PG&E Letter DCL-03-109

Docket No. 50-323, OL-DPR-82
Diablo Canyon Unit 2

Supplemental Information to Support License Amendment Request 03-10, "Revised
Steam Generator Voltage-based Repair Criteria Probability of Detection Method for
Diablo Canyon Unit 2 Cycle 12"

**Supplemental Information on Characterization of Steam Generator Indications
Regarding License Amendment Request 03-10, "Revised Steam Generator
Voltage-based Repair Criteria Probability of Detection Method for
Diablo Canyon Unit 2 Cycle 12"**

Figure 1

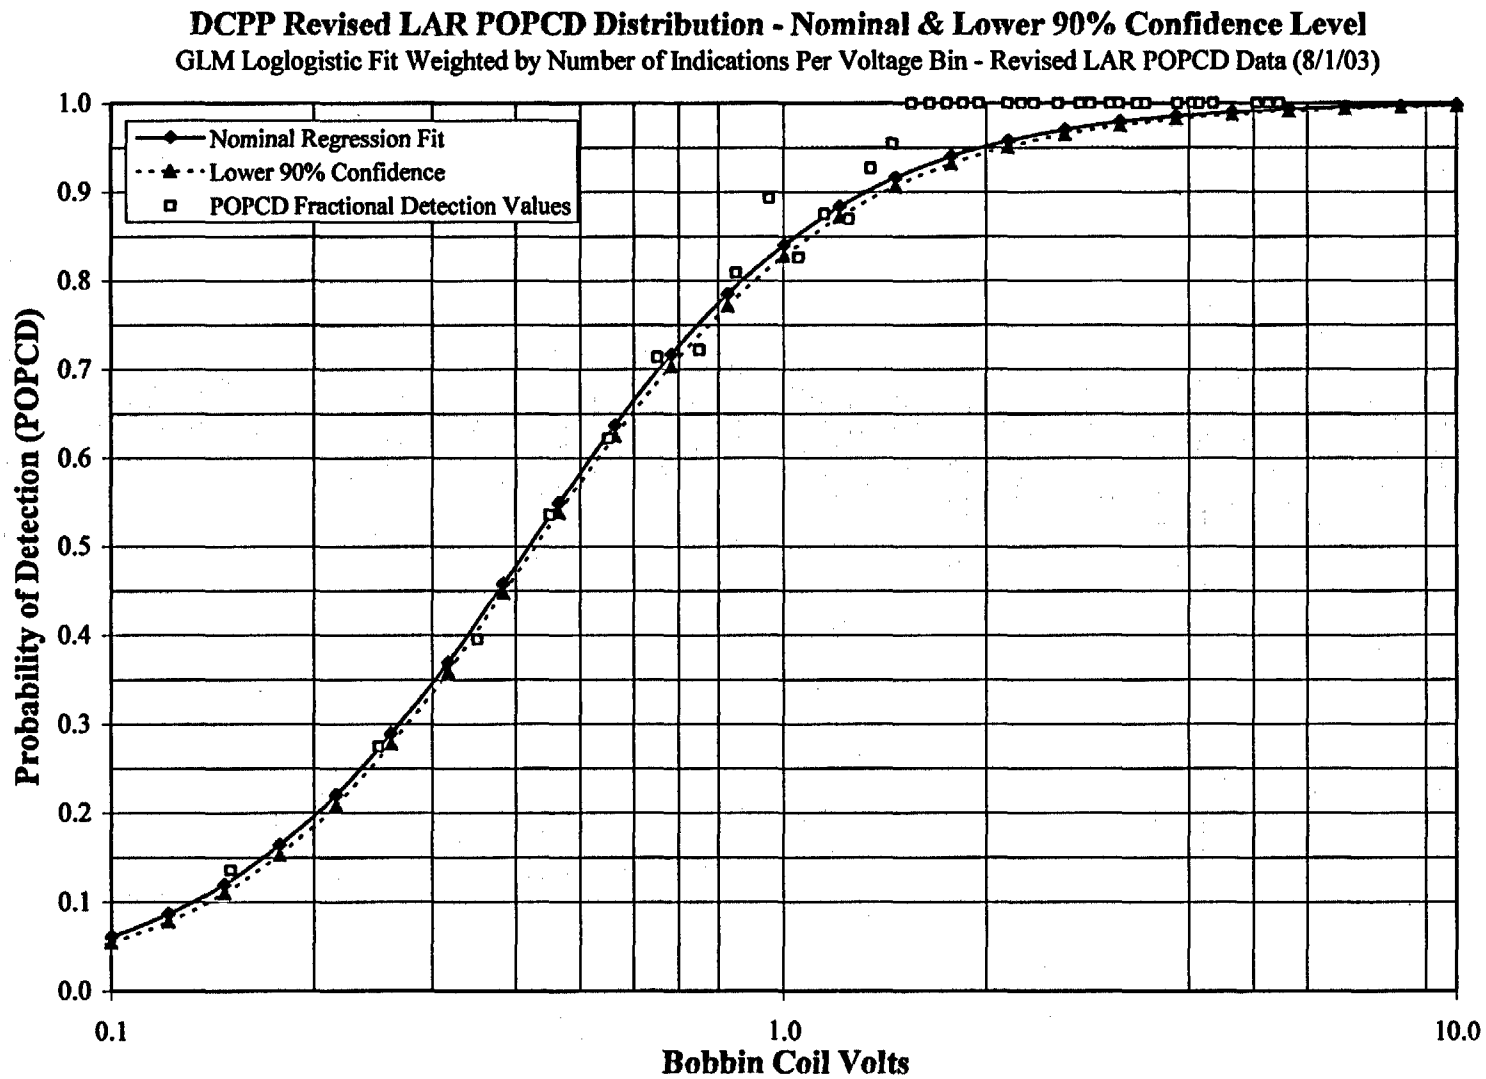
Figure 1 shows the loglogistic fit to the Table 1 Revised LAR POPCD data. The lower 90-percent confidence bound on the POPCD distribution and the fractional probability of detection (POD) data values are also shown for information. The fractional POD values are not used in the general linear model analyses since the POPCD analysis is weighted by the number of detected and undetected indications in each voltage bin. This figure replaces Figure 2 in DCL-03-078.

Therefore, PG&E recommends that Unit 2 Cycle 12 Monte Carlo analysis be based on the Revised LAR POPCD data in Table 1 and Figure 1. This recommendation is consistent with the requirements of GL 95-05, which requires that RPC NDD indications be included in the operational assessment as detected indications. Inclusion of the RPC NDD indications in the POPCD data as undetected bobbin indications would effectively further increase the number of RPC NDD indications in the operational assessment due to the decrease in POD for these indications.

Figure 2

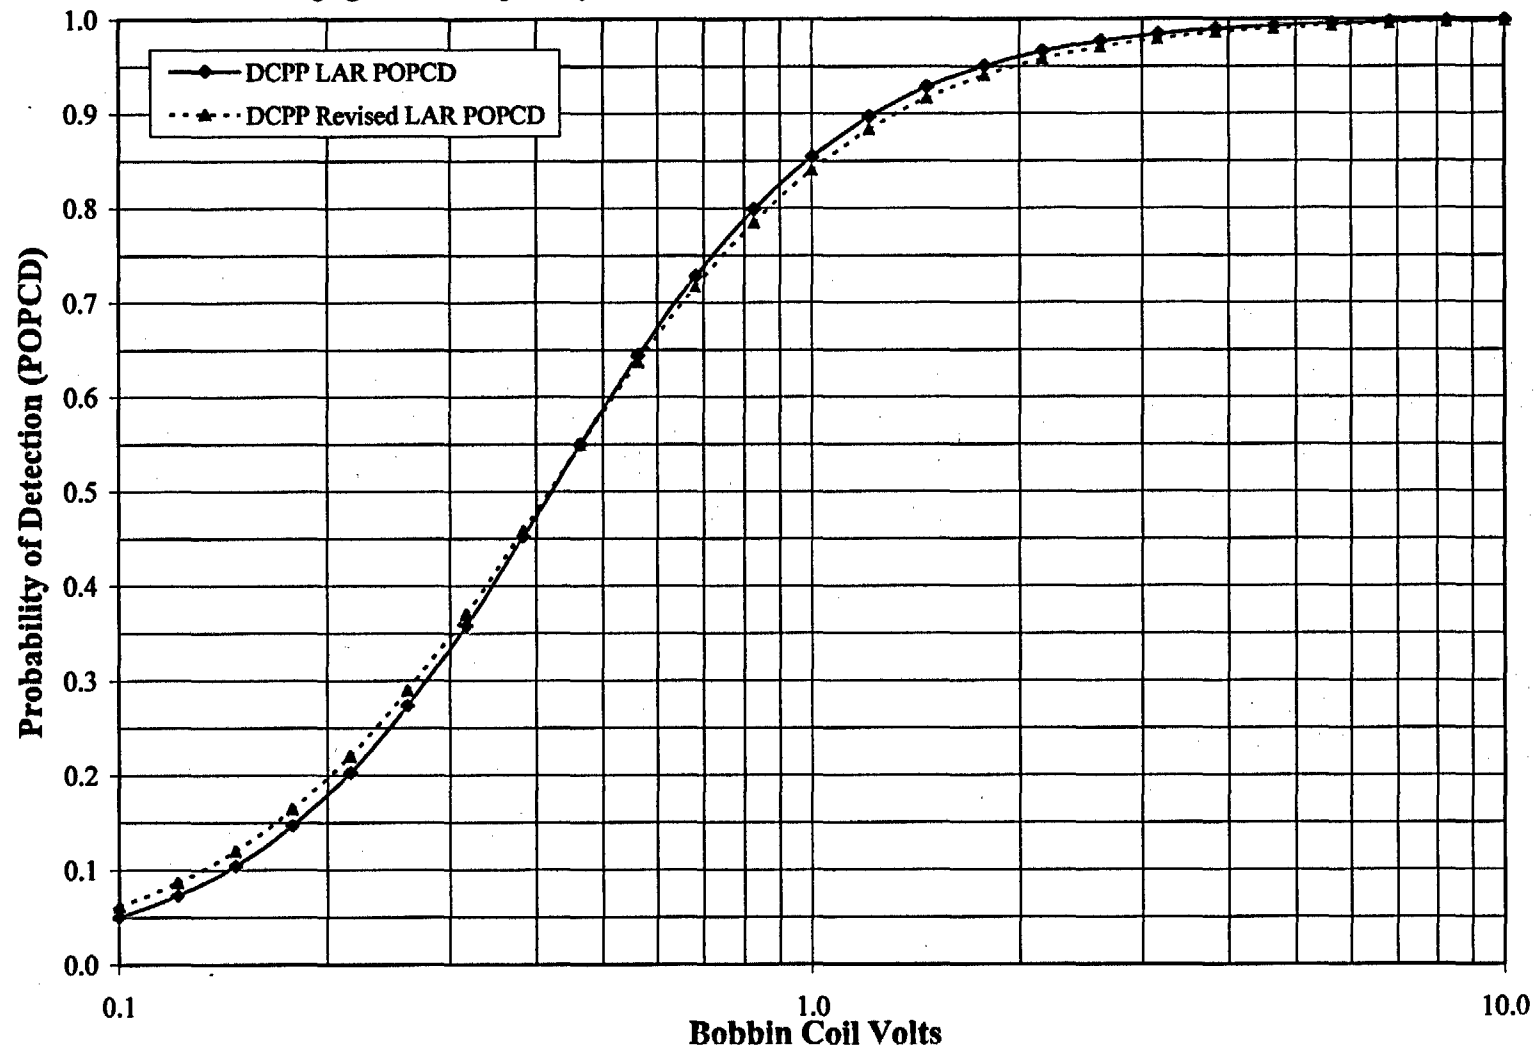
Figure 2 compares the loglogistic Revised LAR POPCD curve with the loglogistic LAR POPCD curve (from Figure 2 in DCL-03-078). Compared to the LAR POPCD data, the Revised LAR POPCD data decreases the POD above about 0.5 volt and increases the POD below about 0.5 volt.
